**WHITE LAKE TOWNSHIP
INTER-OFFICE MEMORANDUM
COMMUNITY DEVELOPMENT DEPARTMENT**

**SUBJECT: Ginko Self Storage
Preliminary site plan approval**
located on the north side of White Lake Road, west of Old White Lake Road, consisting of 2.14 acres. Currently zoned Light Manufacturing (LM). Identified as vacant parcel 12-01-127-004
Applicant: Ginko Investments, LLC

RE: Ginko Self Storage - Preliminary Site Plan Review- 4th Review

RE: Ginko Self-Storage
Preliminary Site Plan and Special Land Use – Review #4

DRAWING TITLE
FIRE TRUCK MOVEMENT

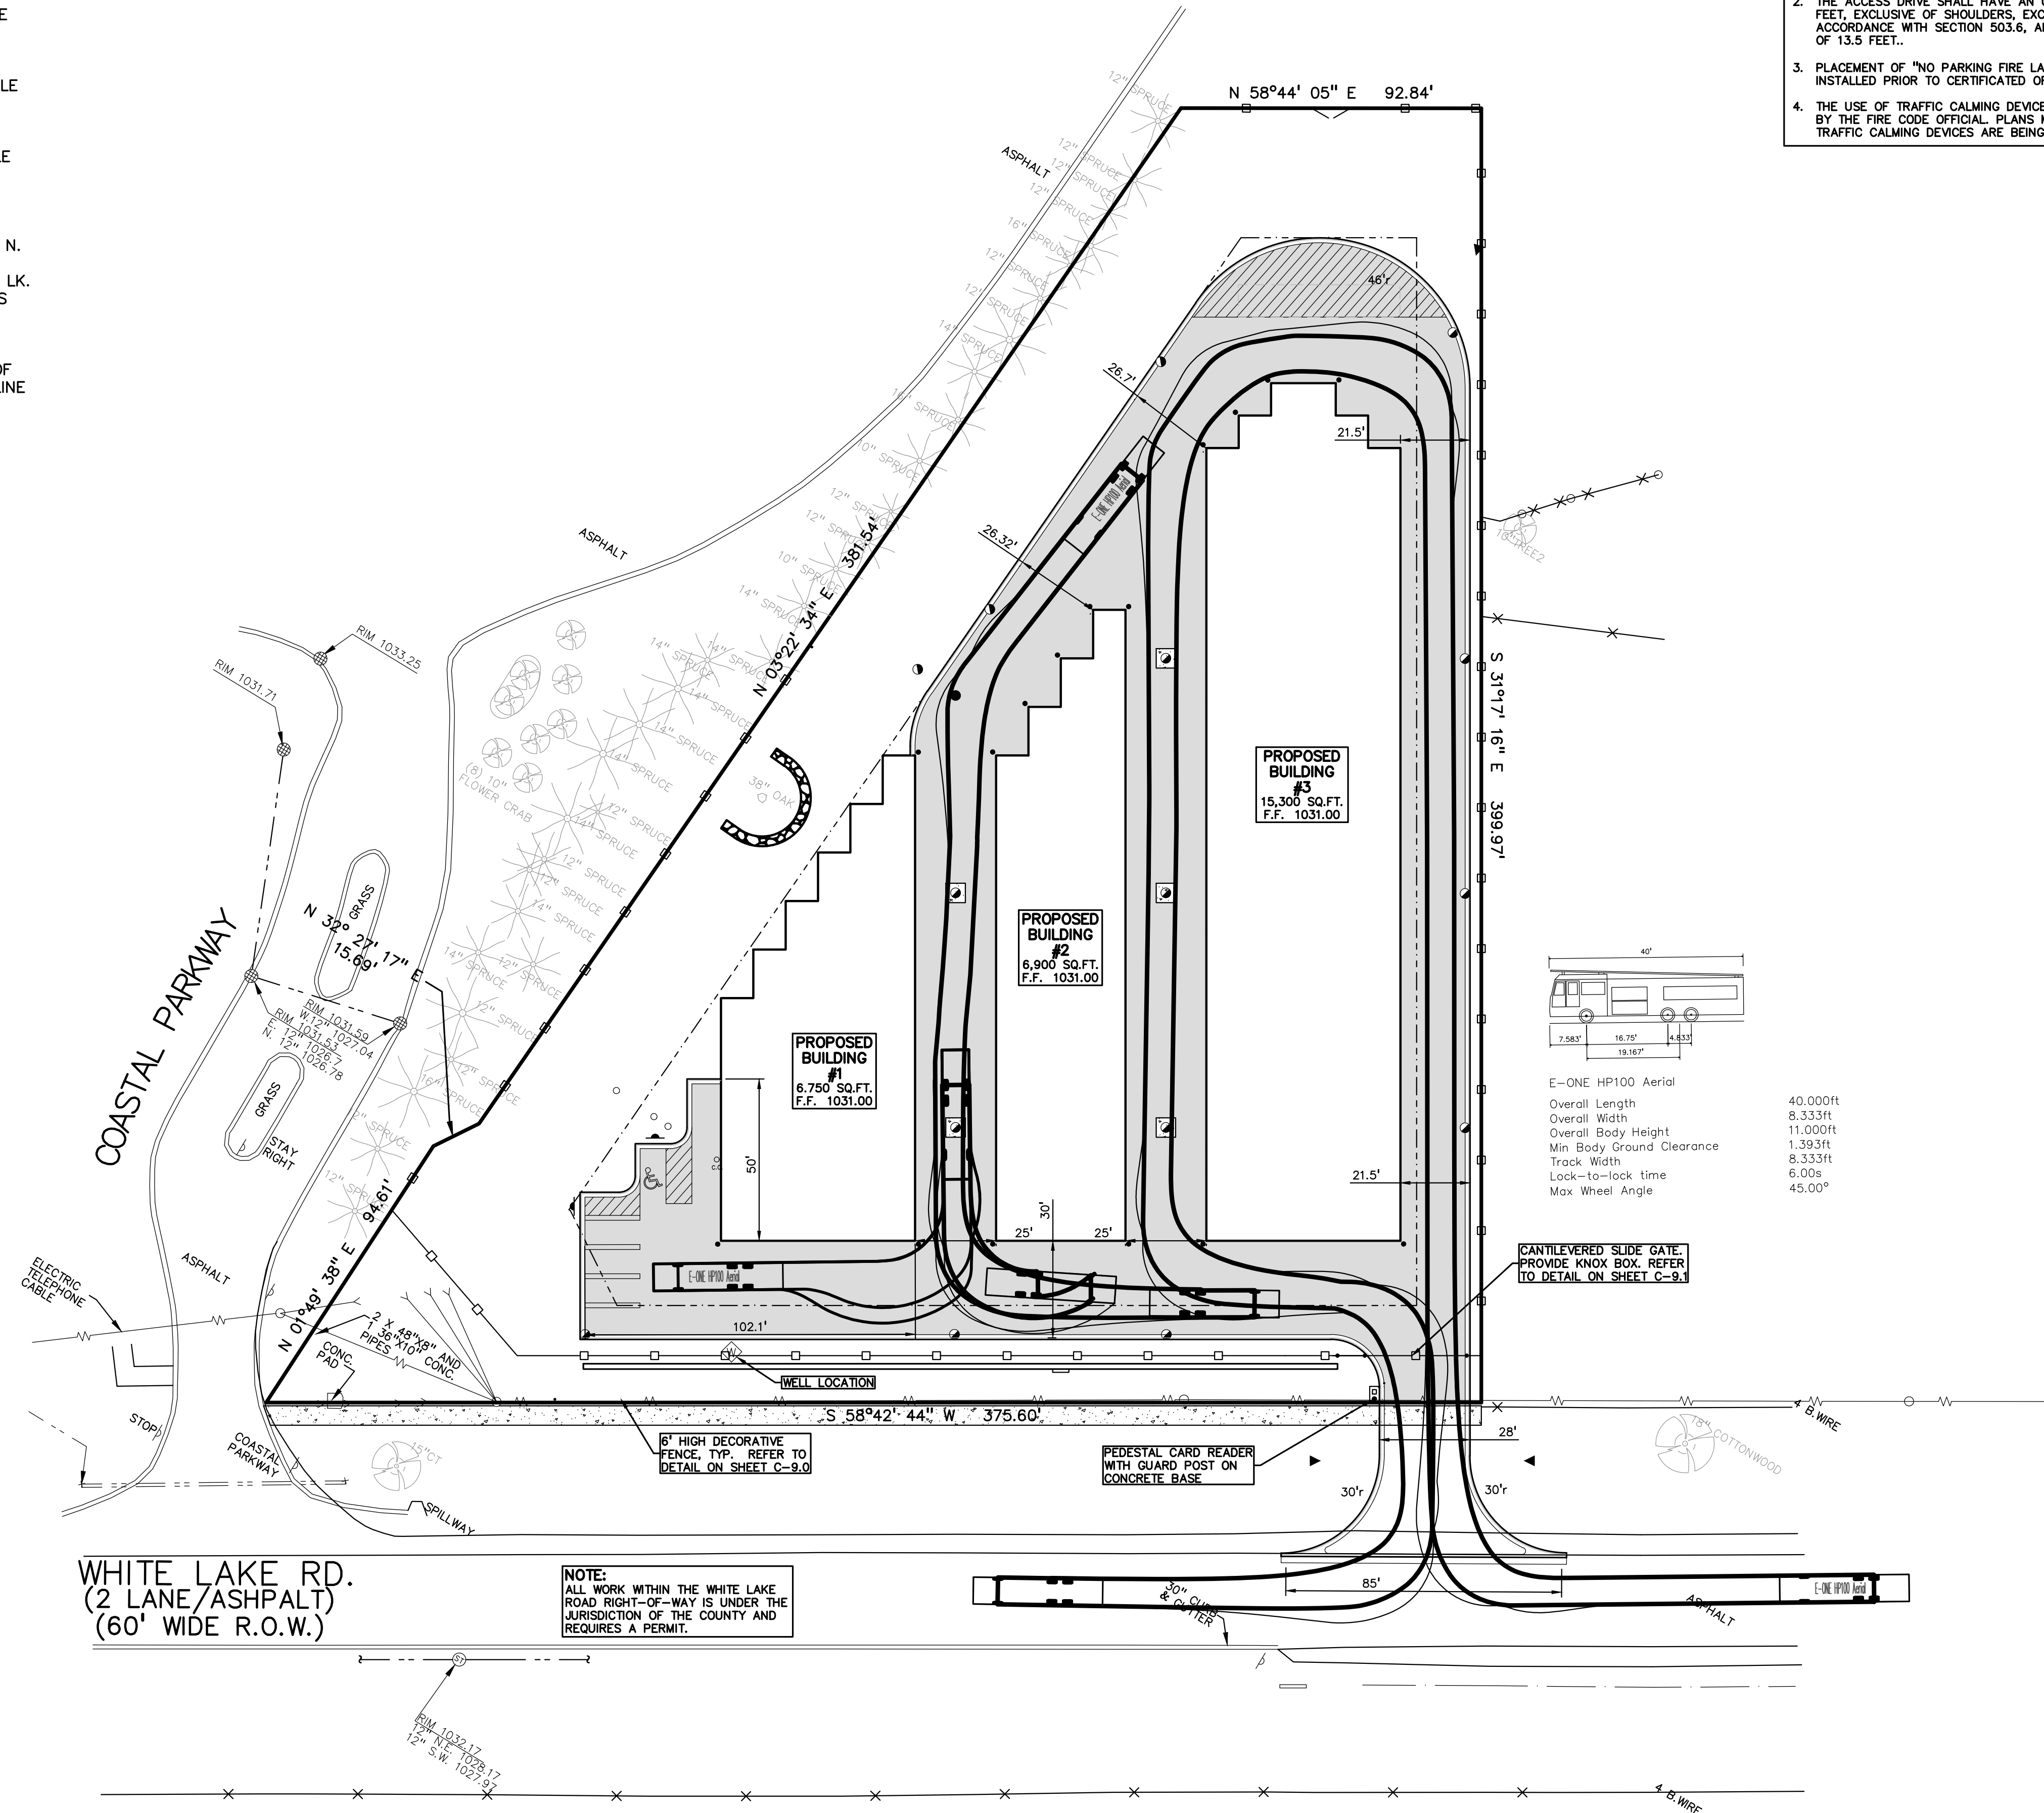
Sheet C-3.1 shall be revised to demonstrate how a fire truck will access Building 1 (via the drive aisle east of Building 1 and west of Building 2?). Can a 40-foot-long truck driving south via the aforementioned access aisle make an east/west turn? (Comments outstanding). (Comments addressed. Sheet C-3.1 has been revised to show the requested turning movements). Pursuant to the zoning ordinance, designation of fire lanes is required at preliminary site plan.

3. The required turning radius shall accommodate the largest Fire Department apparatus (40') and provide a turn radius profile showing apparatus movement on future plans. **Needs to be shown throughout the site plan. (Needs to show movement from the middle drive between building #2 & #3 moving North and turning to the West towards building #1).**

DRAWING TITLE
PRELIMINARY LANDSCAPE PLAN

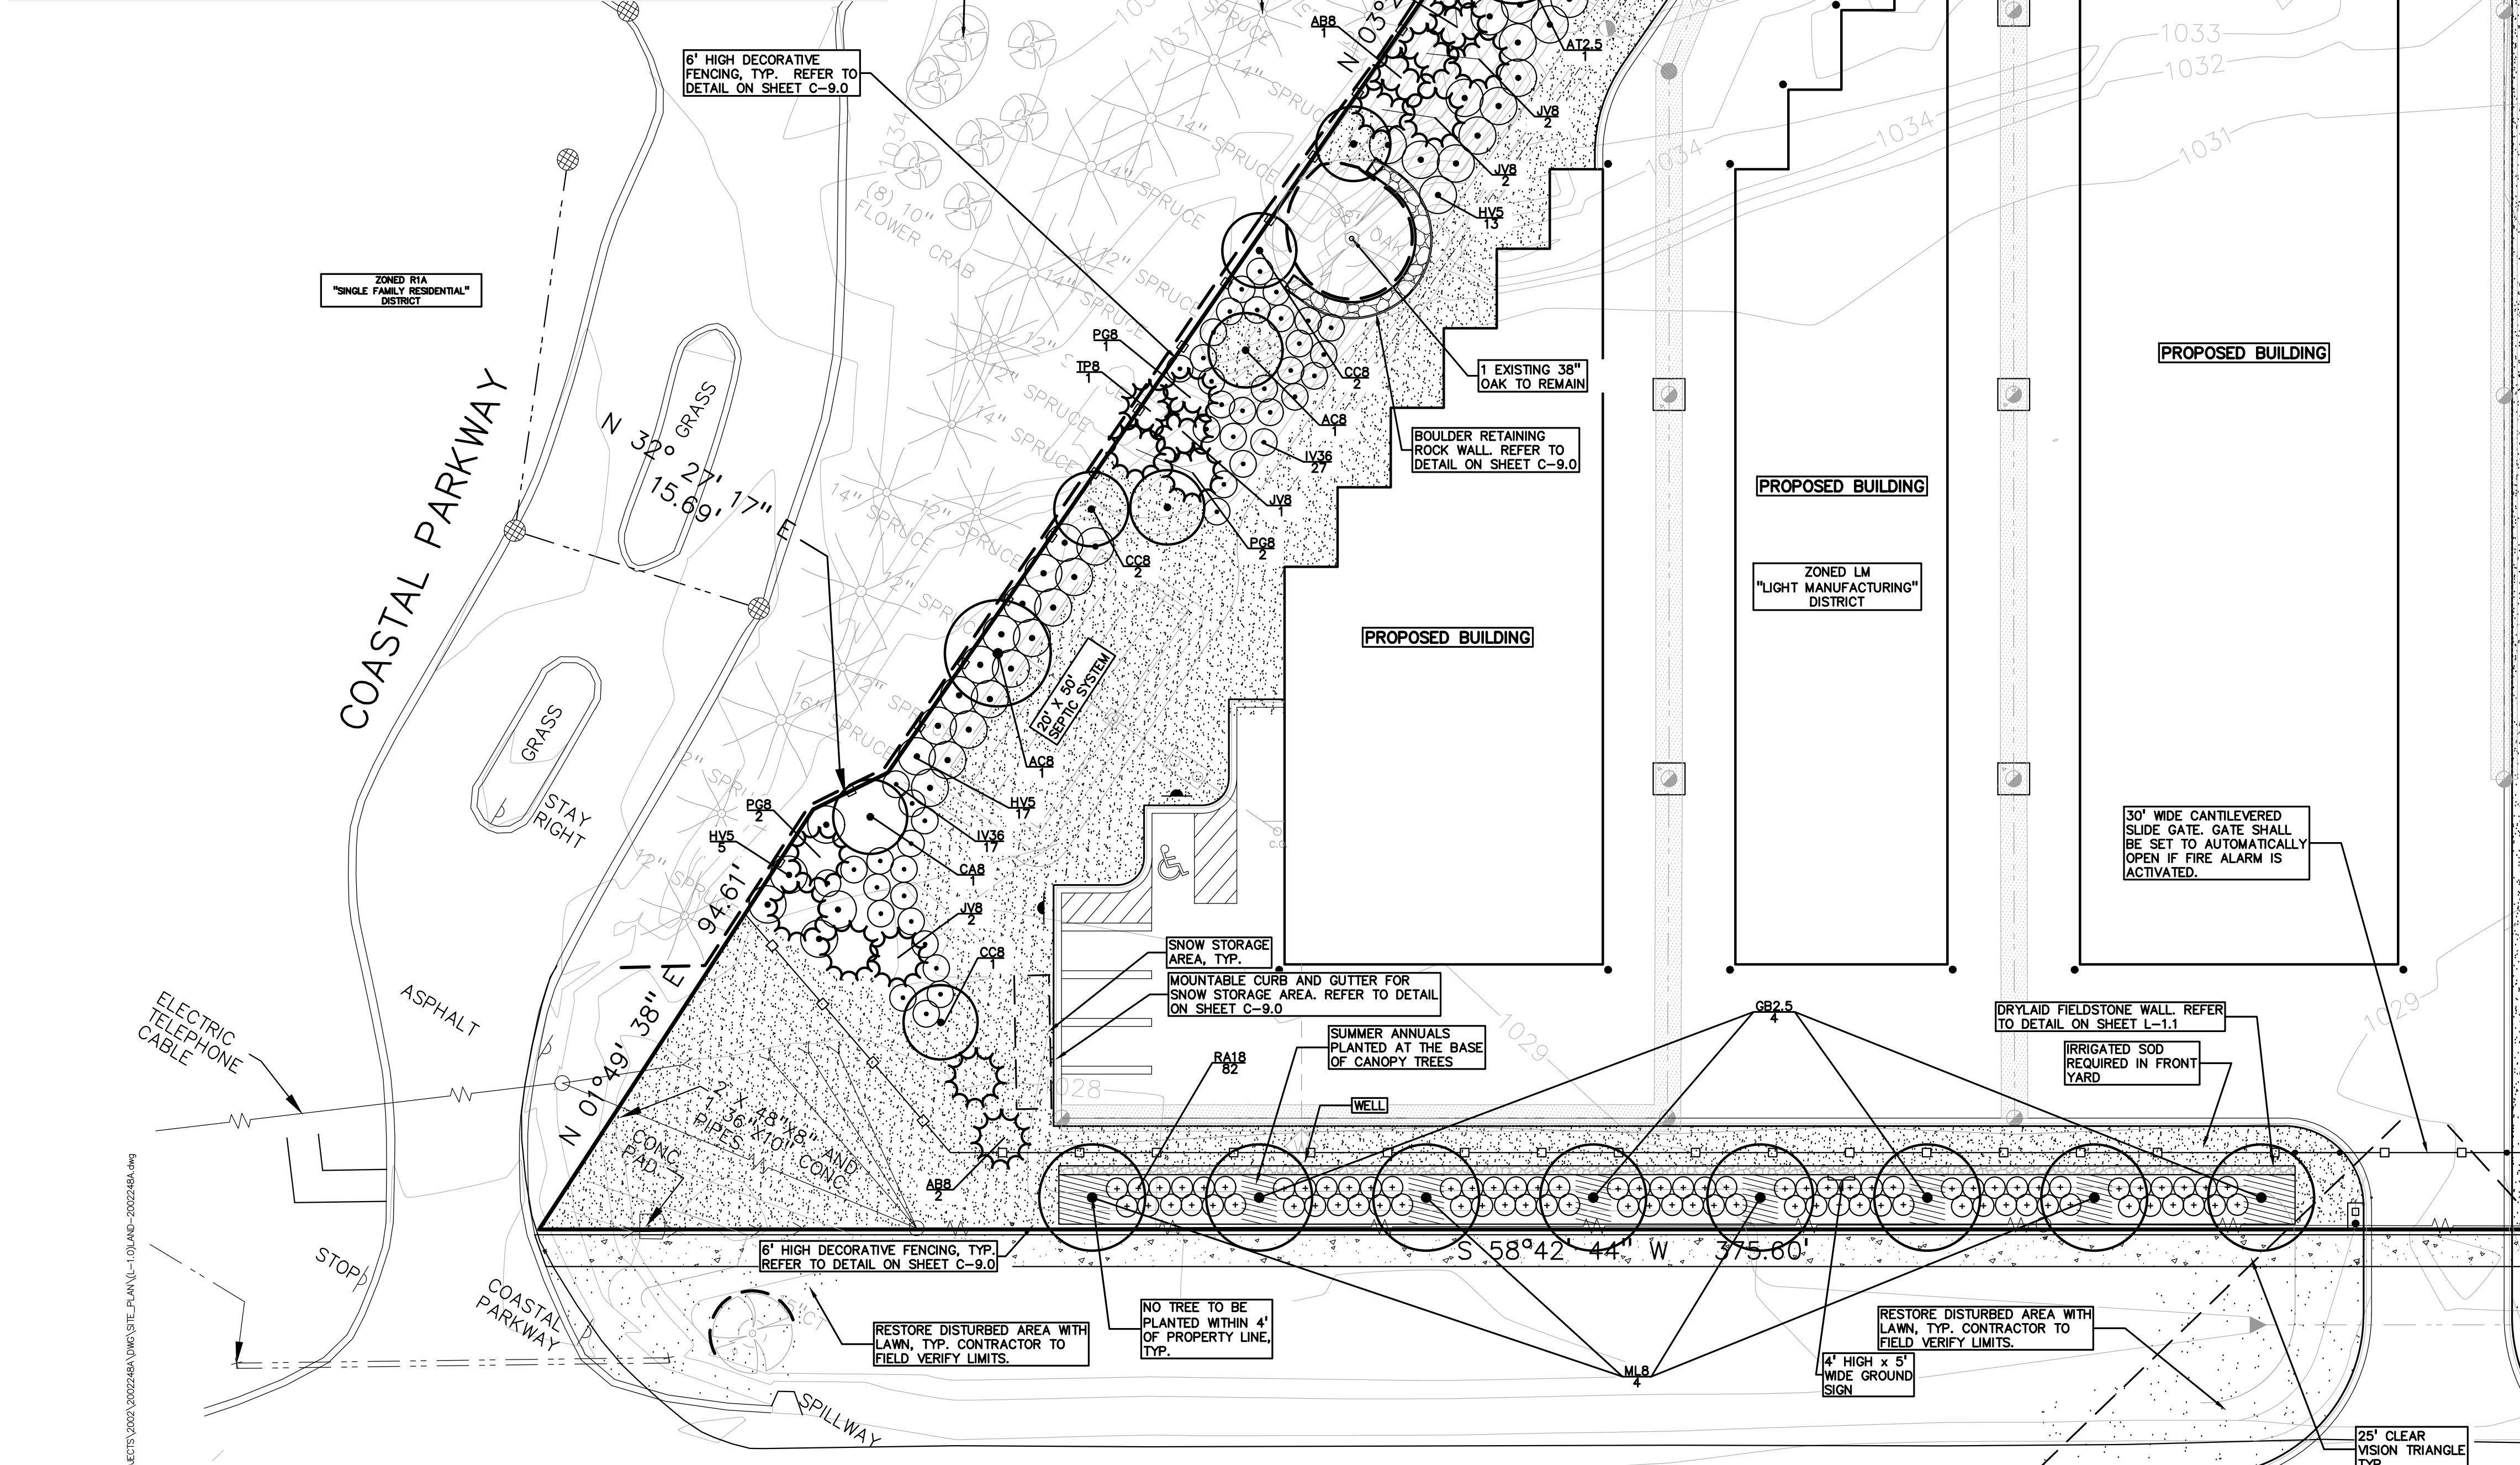
- **The total number of evergreen trees in the Plant List is incorrect. Revise accordingly. (Comment addressed. The total number of evergreen trees has been corrected).**

- **The total number of trees in the Plant List is incorrect. Revise accordingly. (Comment addressed. The total number of trees has been corrected).**
- **233 shrubs are required for interior landscaping and 101 shrubs are proposed. Therefore, a variance is required from the Zoning Board of Appeals. (Comment rescinded. 233 shrubs have been proposed).**

- **47 trees are required for interior landscaping and 33 new trees are proposed. The landscape calculations indicate 48 trees are being counted as interior landscaping. Existing trees on the site being counted towards interior landscaping shall be identified on the plan. Off-site trees shall not be counted as interior landscaping for the proposed self-storage facility. (Comment outstanding. Greenbelt landscaping adjacent to the road right-of-way is being counted as interior landscaping. Therefore, the proposed amount of interior landscaping is deficient and requires a variance from the Zoning Board of Appeals. An extensive land form buffer (six-foot berm landscaped in accordance with the ordinance) is required adjacent to the road right-of-way, but not proposed; therefore, a variance is required from the Zoning Board of Appeals). (The Applicant's engineer stated a variance will be requested).**

- **The common name and scientific name are swapped for some species in the Plant List. Revise accordingly. (Comment addressed. The Plant List columns have been revised).**

- **No more than two planted trees in a row shall be of the same species.** (Comment outstanding. Three Eastern Red Cedar trees are planted in a row along the west property line). (Comment outstanding. Three white spruces in a row are now proposed along the west property line). (Comment addressed. The landscape plan has been revised accordingly).

- **Pine trees are prohibited in the Township. Replace White Pine with a different evergreen species.** (Comment addressed. Pine trees are no longer proposed).

- **Lawn in the front yard shall be sod and lawn elsewhere shall be hydroseed or sod.** (Comment addressed. It appears irrigated sod lawn has been proposed around the entire site except in the landscaped area along the west property line. In the Key on Sheet L-1.0 there is a symbol for restored lawn, though staff did not locate any such areas on the plan. If not proposed, this item shall be removed from the Key). (The Key has been modified to indicate restored seed lawn at areas disturbed in the right-of-way or adjacent properties).
